**United States Court of Appeals  
For the Fifth Circuit**

No. 21-60743

**APPENDIX VOLUME V**

Review of ISP DEIS, ML20122A220

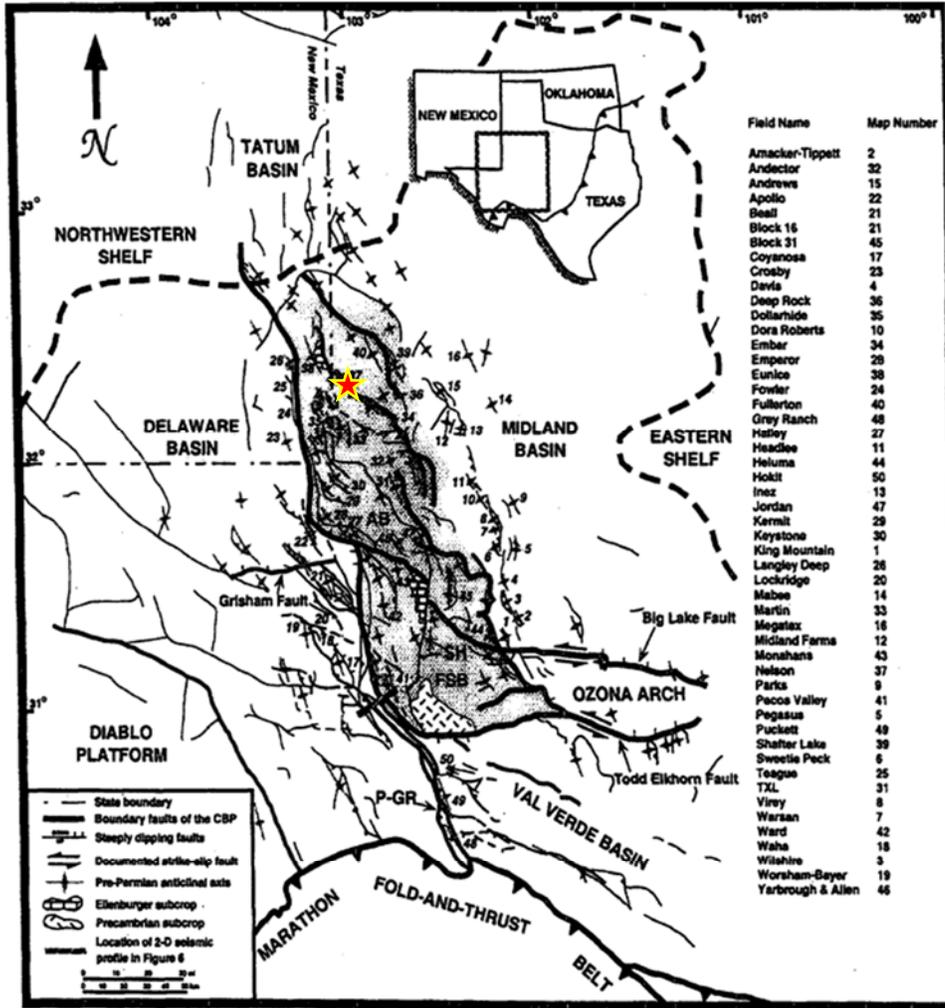
While this description is true for the Western flank of the CBP, the NRC fails to disclose the heavily faulted nature of the CBP itself in and around the ISP’s proposed location (see Figure 1 below).

Figure 1. Image shows highly complex fault network with regional trends through and around the IPS's site location. The west side of the Central Basin Platform (CBP) has "greater structural relief, vertical separation, and basement shortening" than the eastern side (Tai and Dorobek, 2006). Approximated WCS location outlined by red star.

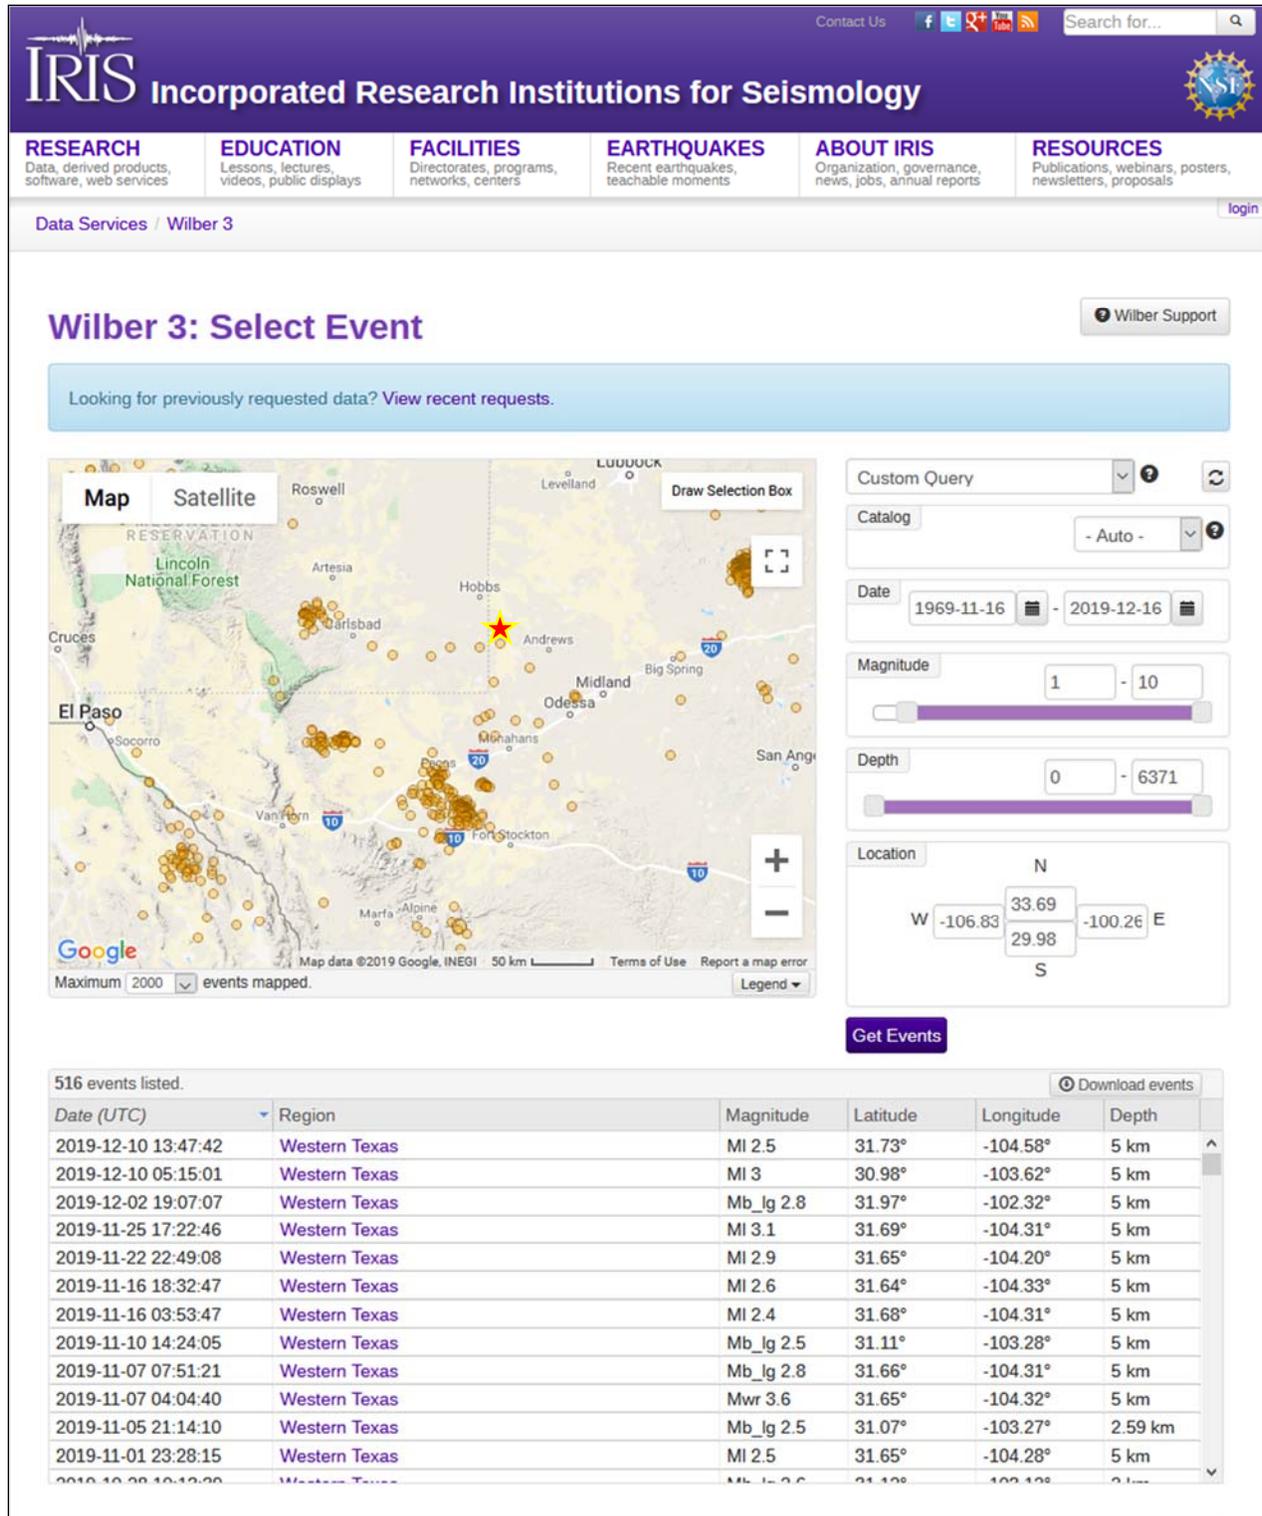
However, most earthquake epicenters in the ISP’s site are at depths related to basement faulting (see Figure 2 below), showing that the risk in this area comes from reactivation of basement faults propagating energy felt at the surface, not the reactivation of Quaternary age faulting. These Quaternary faults are used as the sole basis for seismic risk stated repeatedly throughout the DEIS (pg 4-27, line 8-10 & 39-45) as proximity to a hazard even though they pose less risk to the site and environment than the above-mentioned subsurface faults.

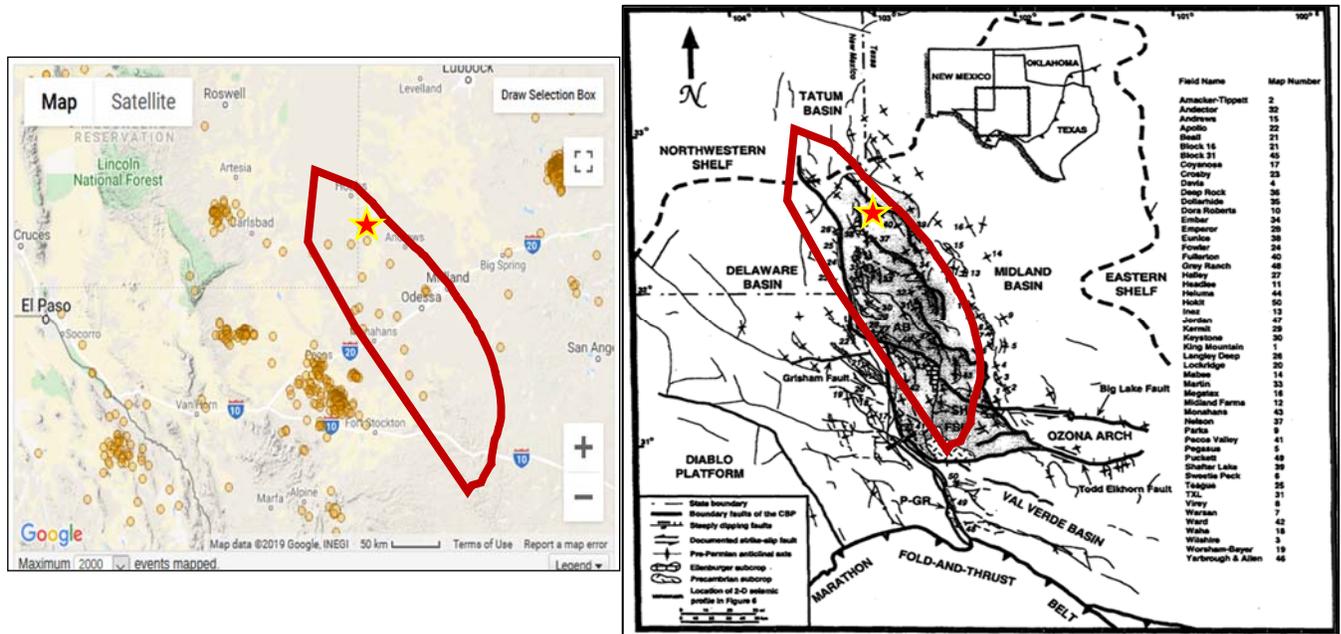
A comparison of the earthquake data and CBP fault maps show a correlation of events running through and around the ISP proposed CISF site (see Figure 3 below).

The omission of the obvious risk posed by these basement faults by the NRC in the DEIS gives cause for concern to the Probabilistic Seismic Hazard Analysis (PSHA) performed by the ISP applicant and submitted to the NRC (pg 3-21, line 3-21).

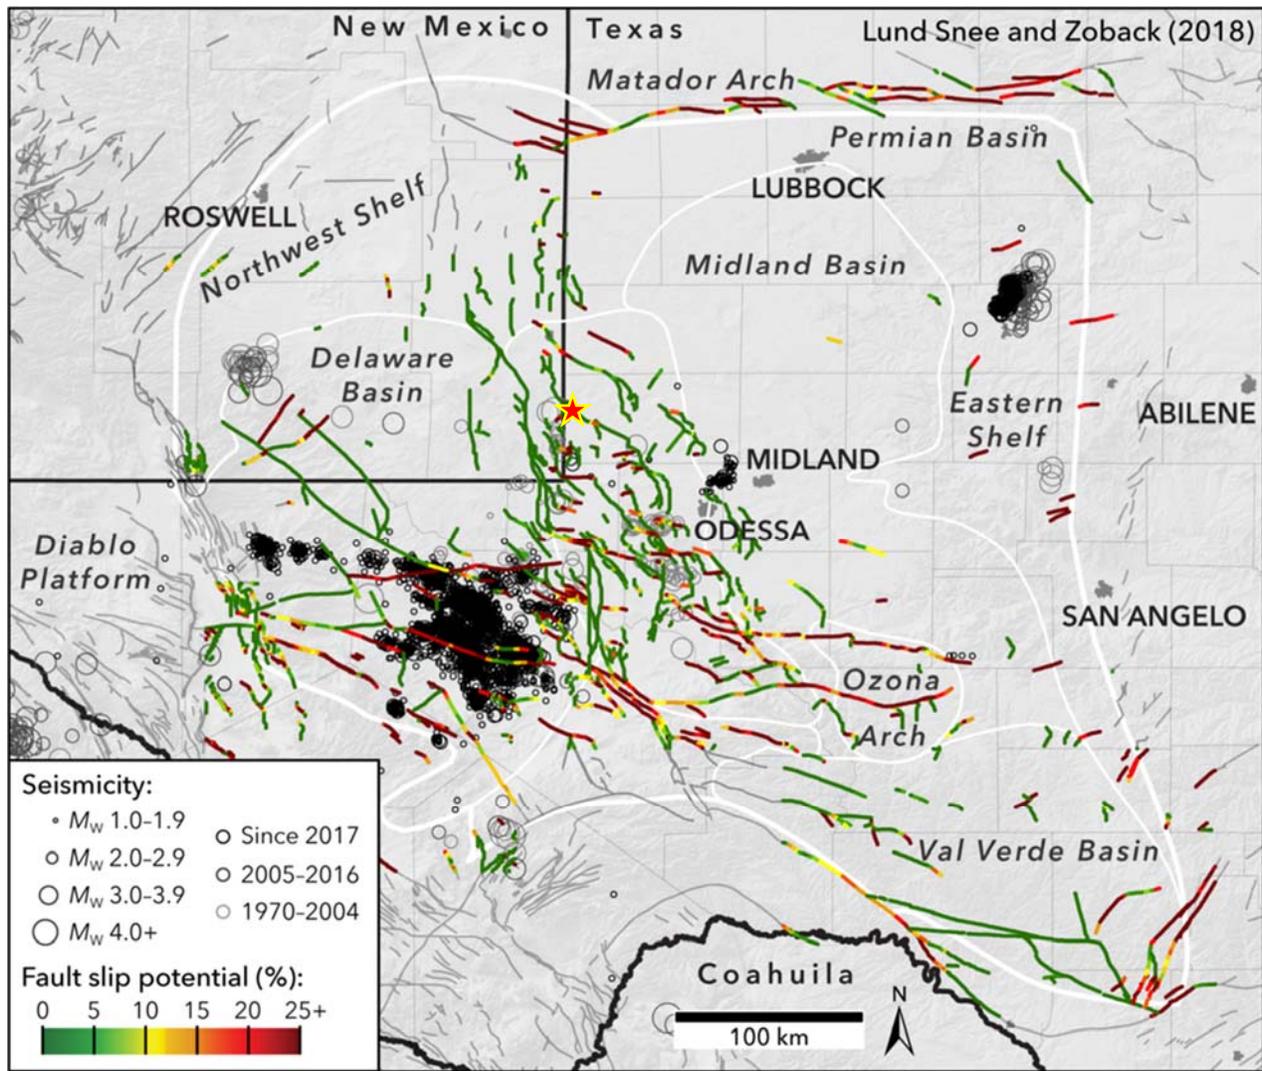
The DEIS references the Snee and Zoback (2018) study that is cited (pg 5-21, lines 1-11) as giving a LOW RISK evaluation for the site due to future earthquake caused by oil and gas operations. Figure 4 shows very clearly that the fault networks that are used by Snee and Zoback (2018) are surrounded by faults and are in proximity of some that show a 45% likelihood of slip in the future under these conditions.

It is hard to see how the ISP applicant declares that the site is at a less than 10% risk of fluid induced fault slip, or how the NRC would accept these findings based on the literature that they have cited as the basis for their analytical findings.

Figure 5. Salado Formation

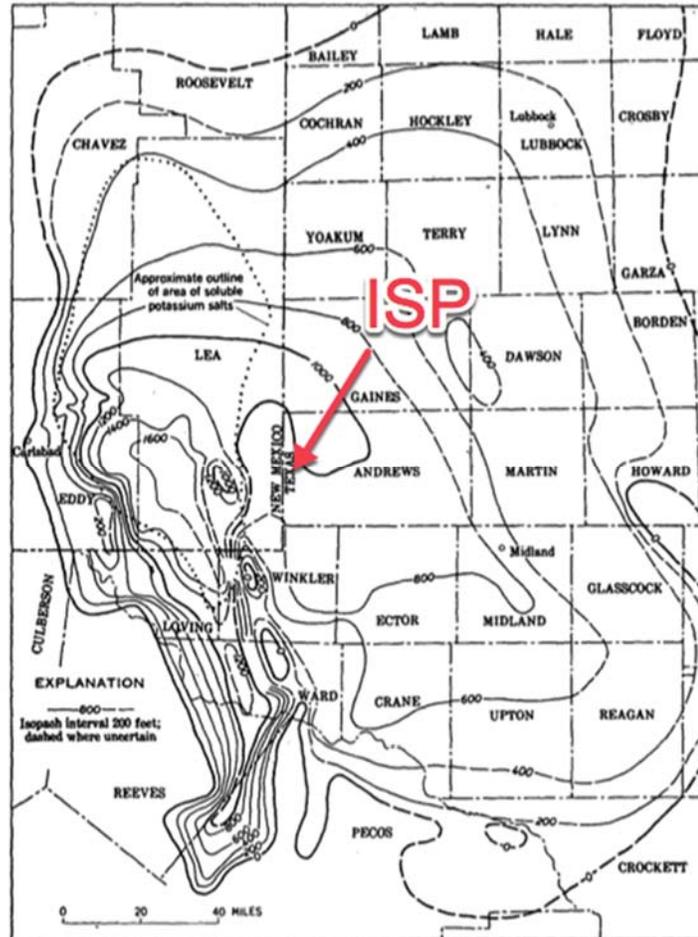
“Rather extensive deposits of salt are exposed in a salt basin west of the Guadalupe Mountains in western Texas and southeastern New Mexico, about 70 miles southwest of Carlsbad, N. Mex. (Richardson, 1904, p. 61-64; King, 1948, p. 160-162). ... These deposits are in or near existing salt lakes. It is not known whether the salt is introduced into the waters of the lakes as a dissolved constituent in surface water or by the percolation of ground water from deeply buried salt beds.”<sup>5</sup> [emphasis added]

Figure 8. NOAA Dust Storm Frequencies, 1988-2011

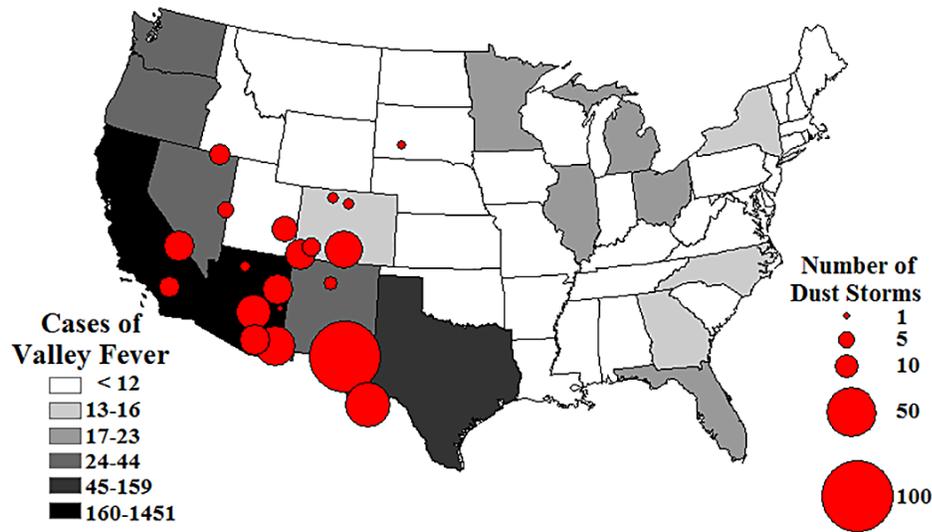
How are surface salt deposits in the immediate vicinity of the proposed ISP facility a threat to the SNF storage operations? The growing frequency of the meteorological phenomenon of “haboobs” and sandstorms in the region are a highly effective means of delivering tons of surface sediment to the SNF operations, even in a single haboob event (Figures 4 and 5).<sup>7</sup>

As reported by NOAA, the area of the US with the highest frequency of dust storms is an area of southeastern New Mexico and West Texas that includes the Salado Formation and the proposed ISP site. In recent years, the dust storms have frequently been manifested as Haboobs in eastern New Mexico and West Texas.
